DRAFT
Environmental Impact Statement

Appendix 17B

Supplemental PCN Information

The Belleayre Resort at Catskill Park

Revisions
Project 03055
Date 4/15/03
CAD # PCN-7010-17
Drawing D-1

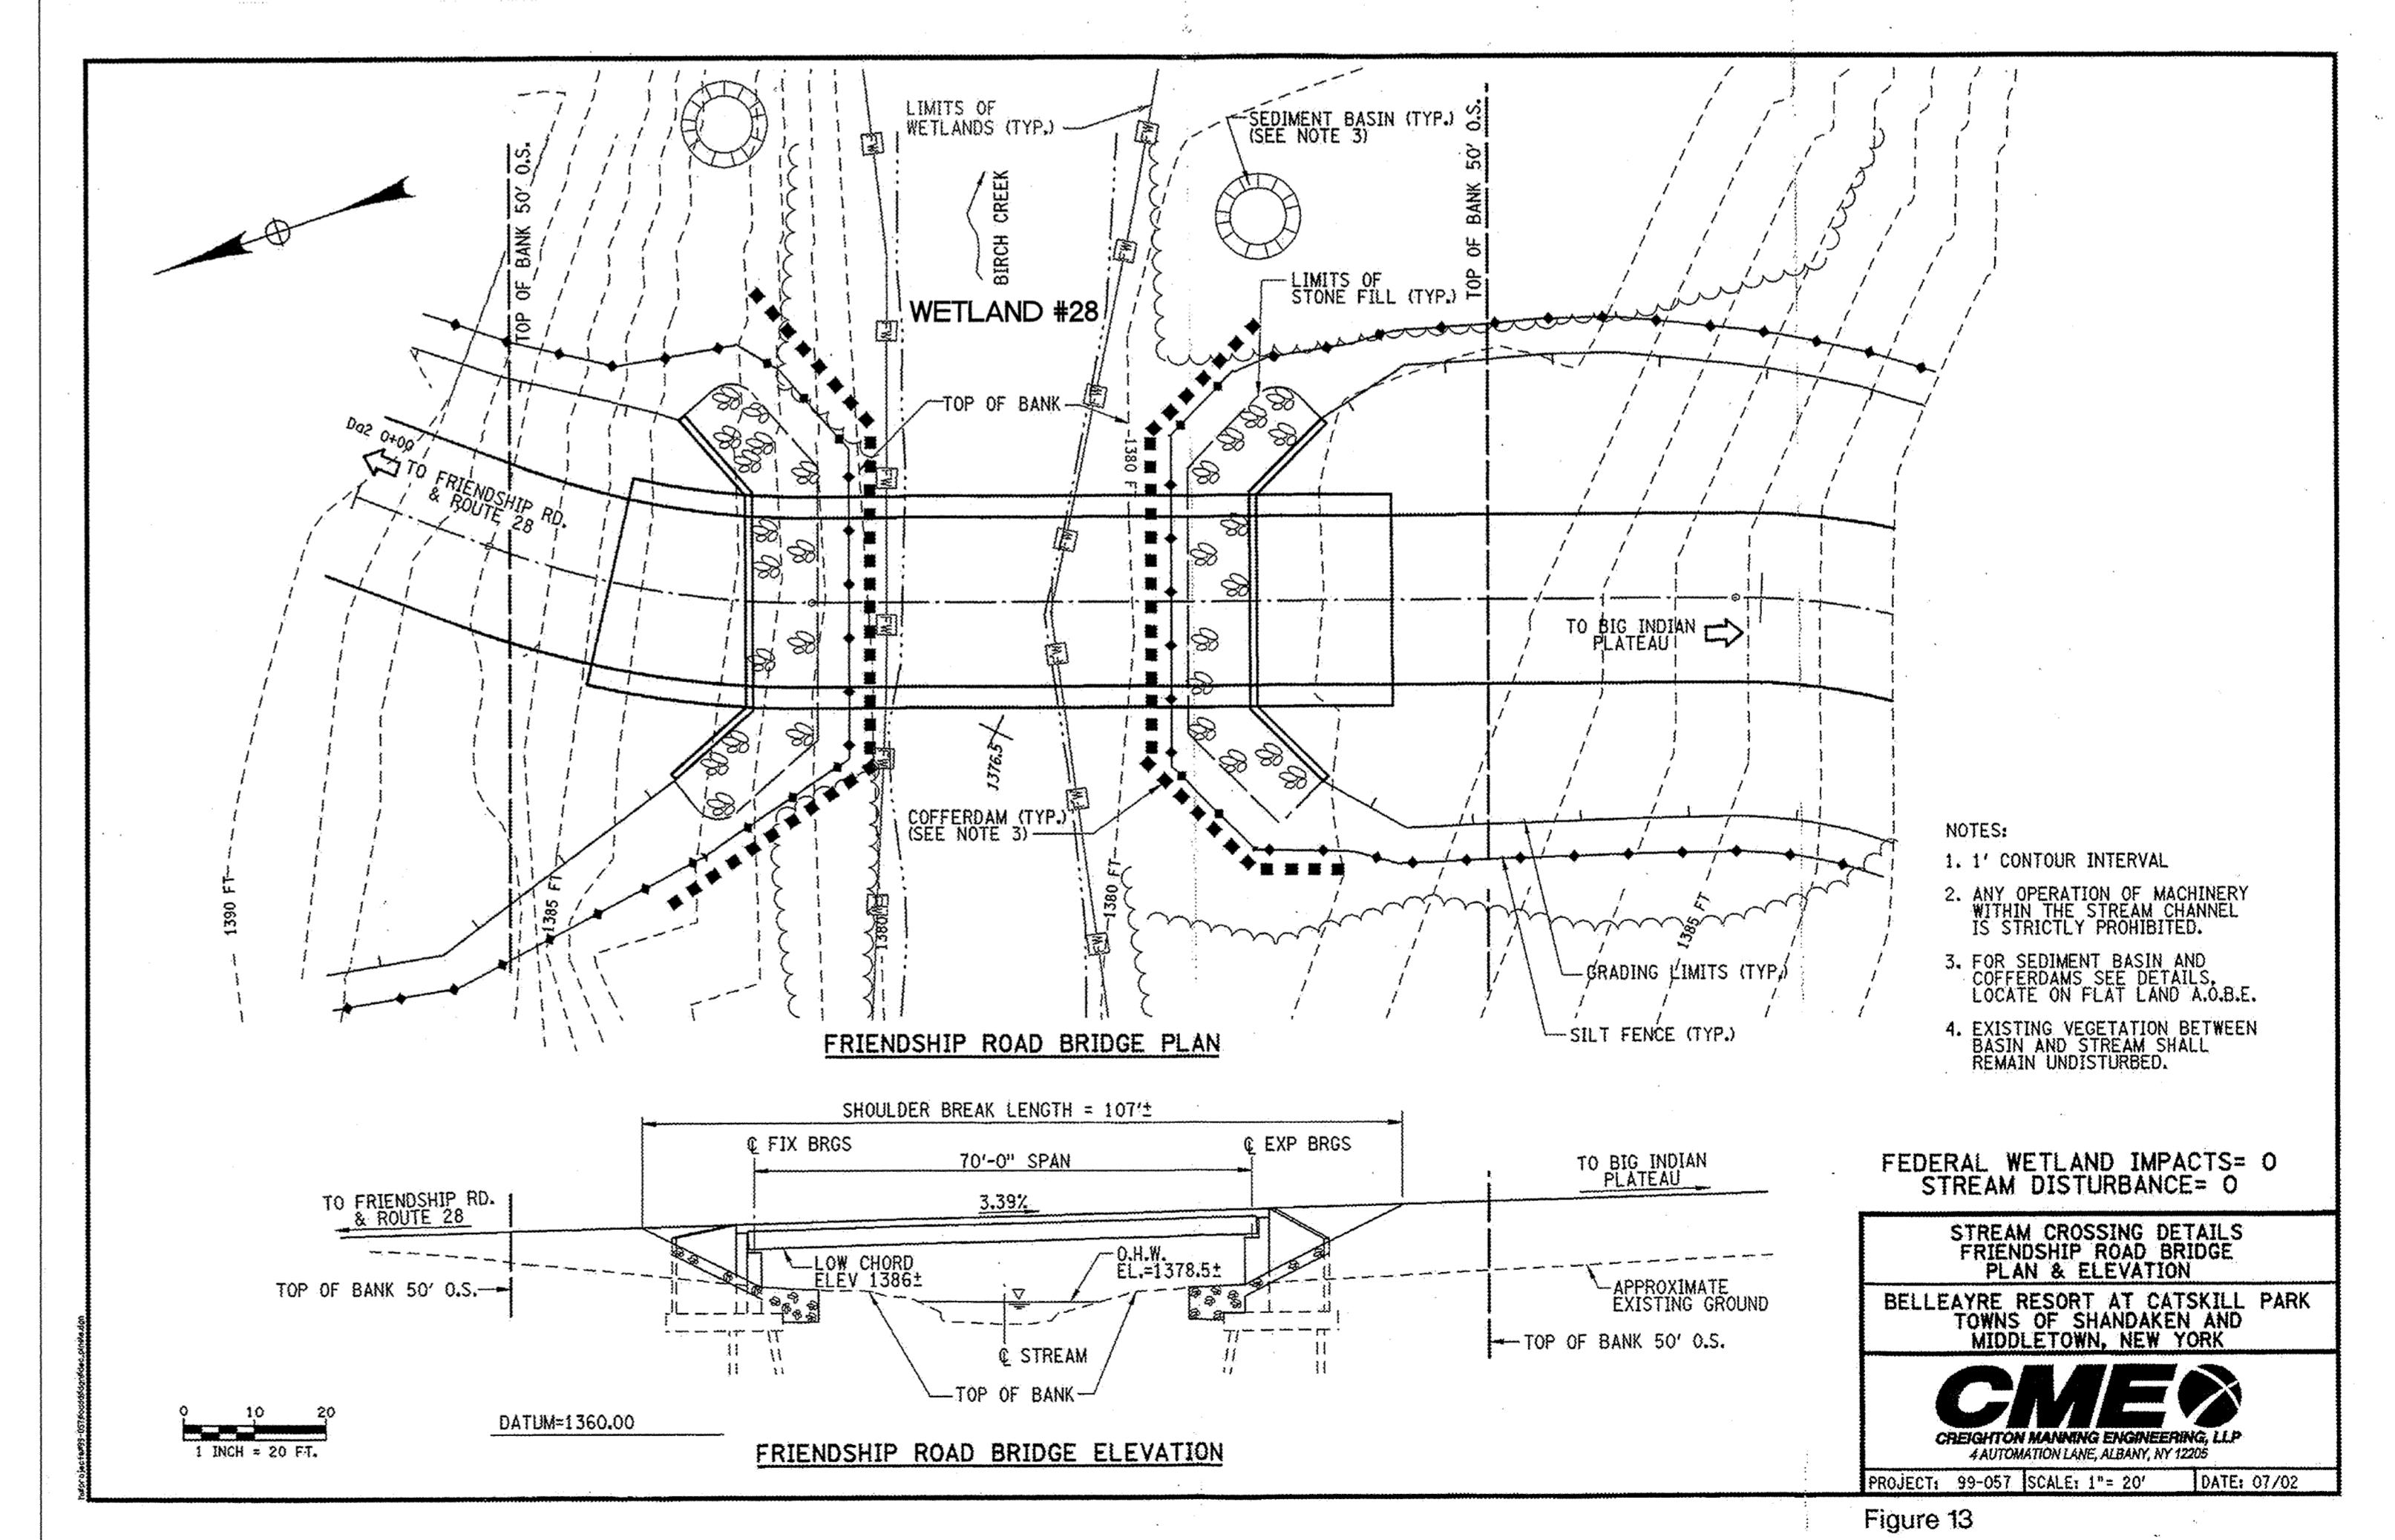
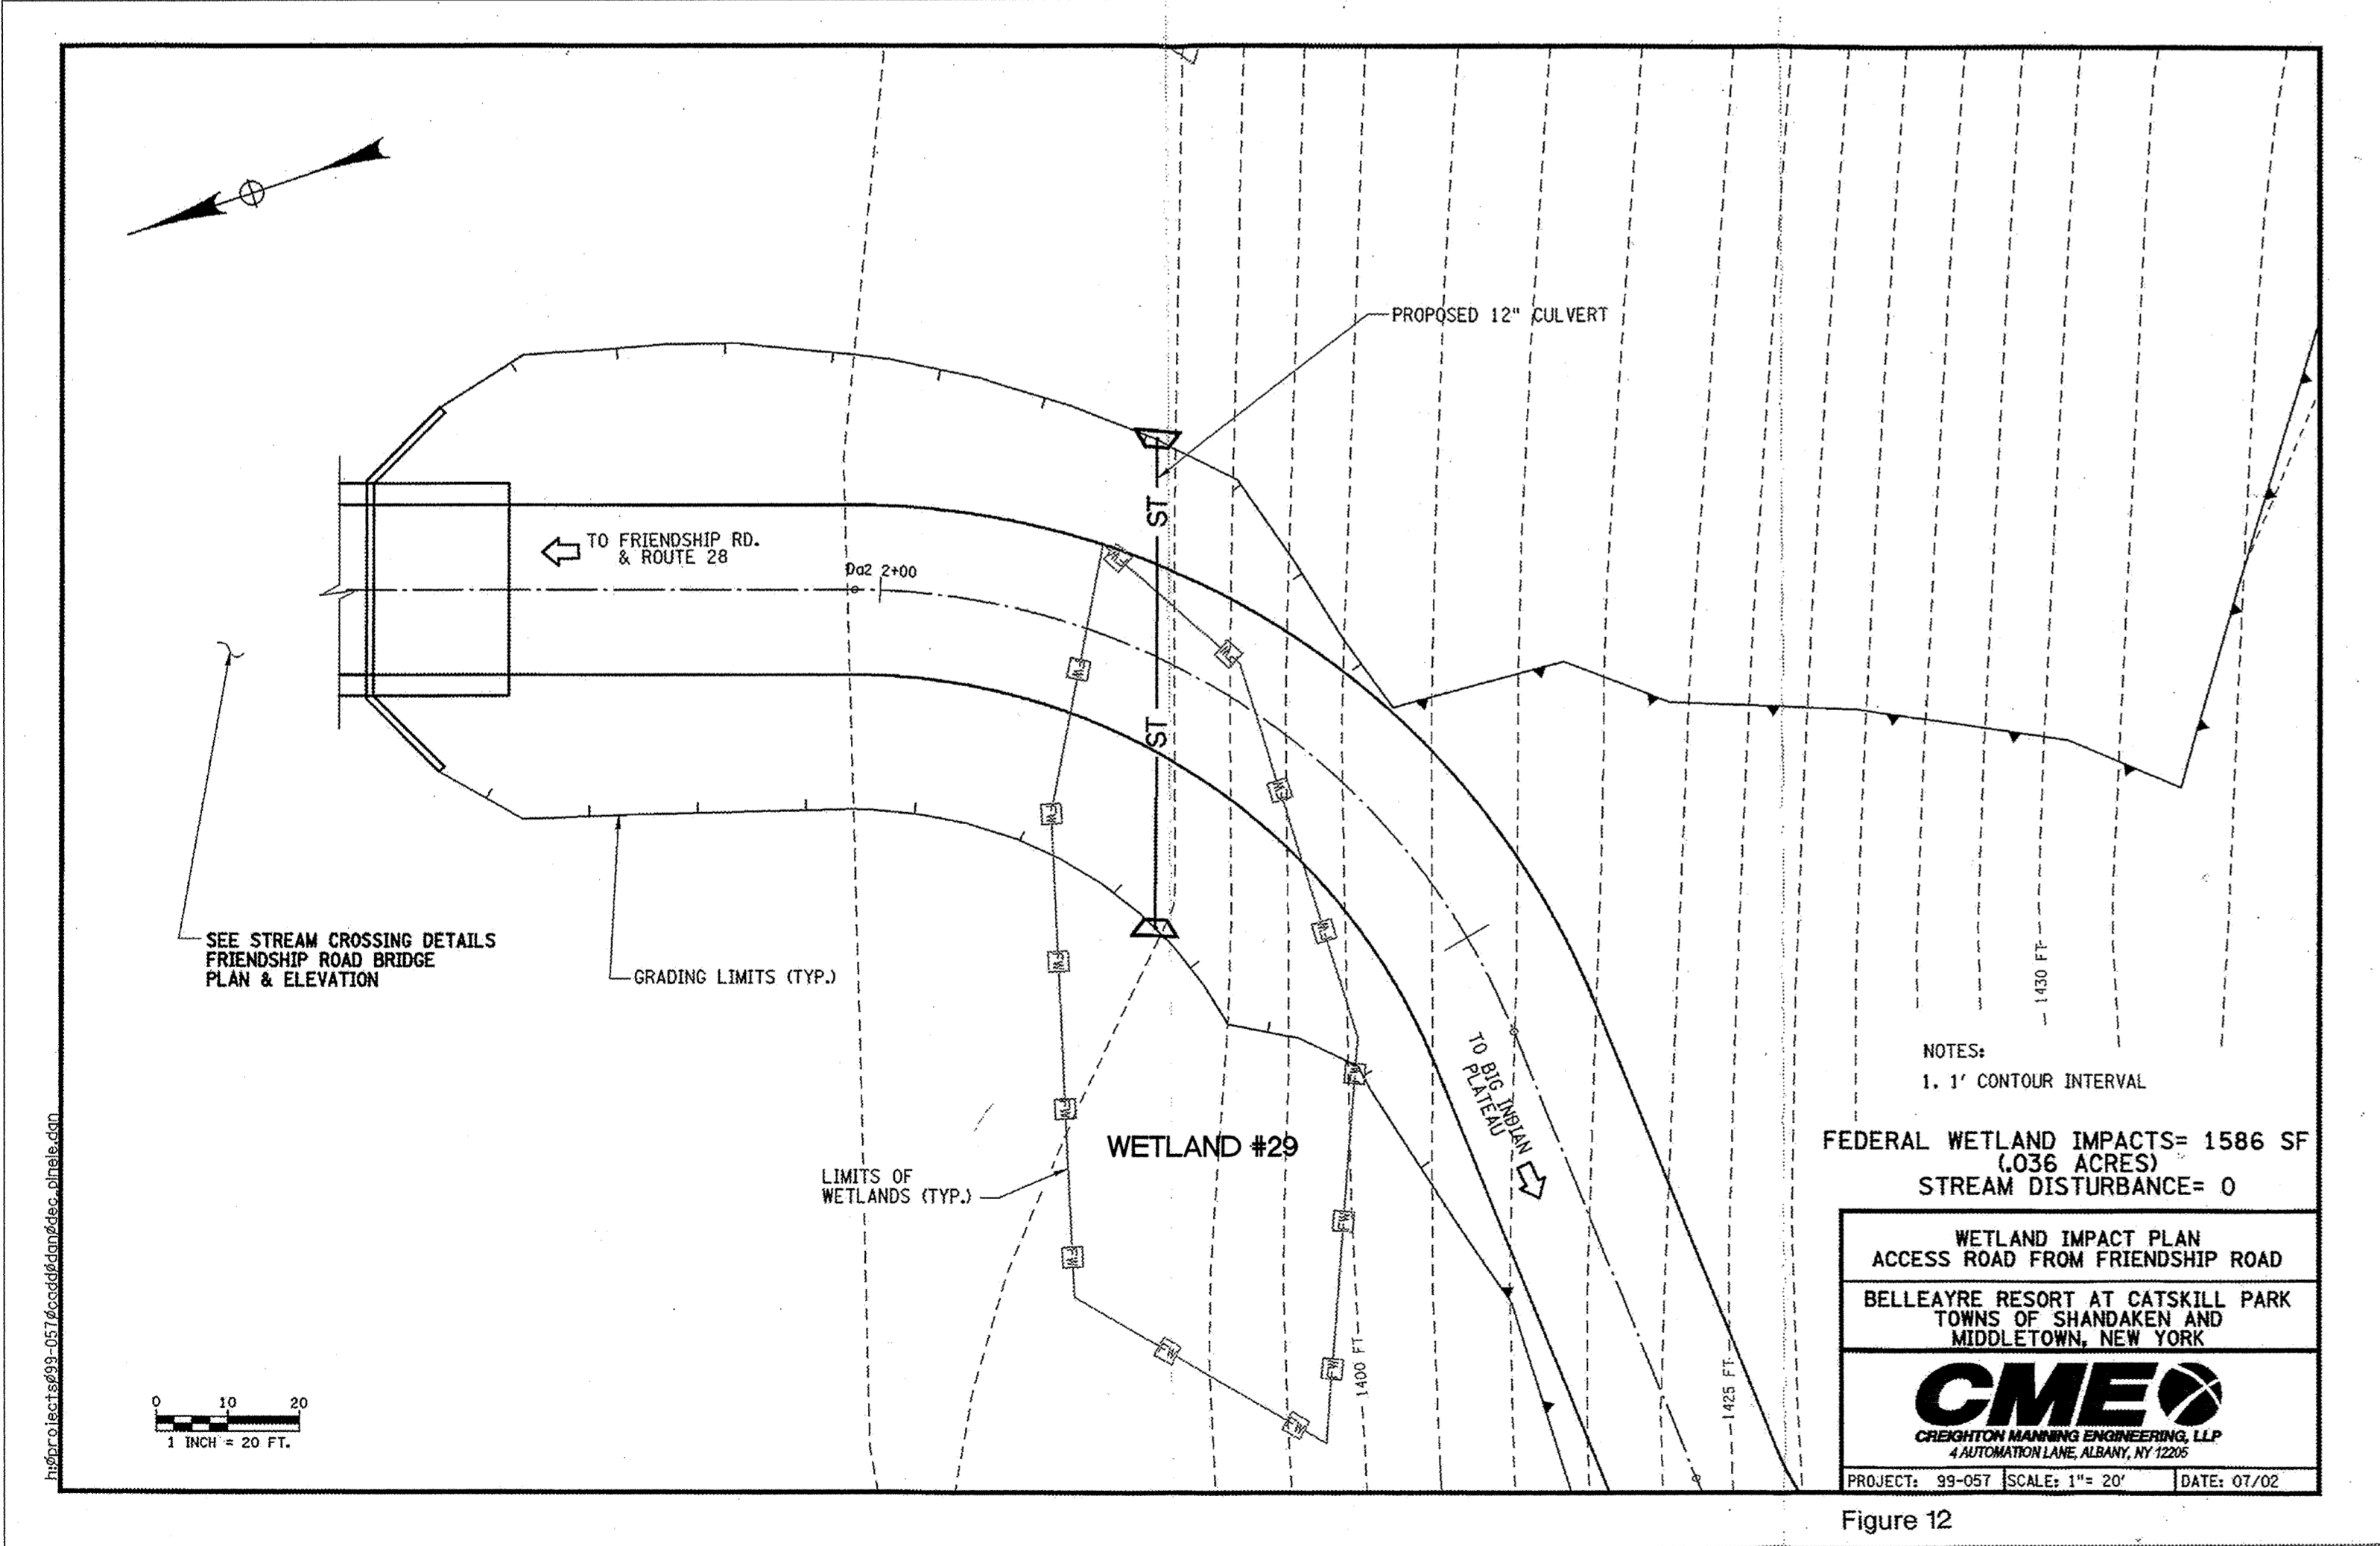
The tree clearing protocols from Exhibit 6 have been revised and a copy is included on Detail Sheet D-1. The revisions deleted the alternative removal method that involved winching. This method is no longer proposed.

A revised Figure 10 has also been added to Detail Sheet D-1. The revision to this figure shows a cart path with a deck higher above existing grade. A note has also been added stating that the deck height above grade is to be equal or greater than the deck width. The great majority of the proposed decking will be 5 feet wide, but there will be some short

Figure 11 has been added to Detail Sheet D-1.

Figures 12 and 13 have been added to Detail Sheet D-1.
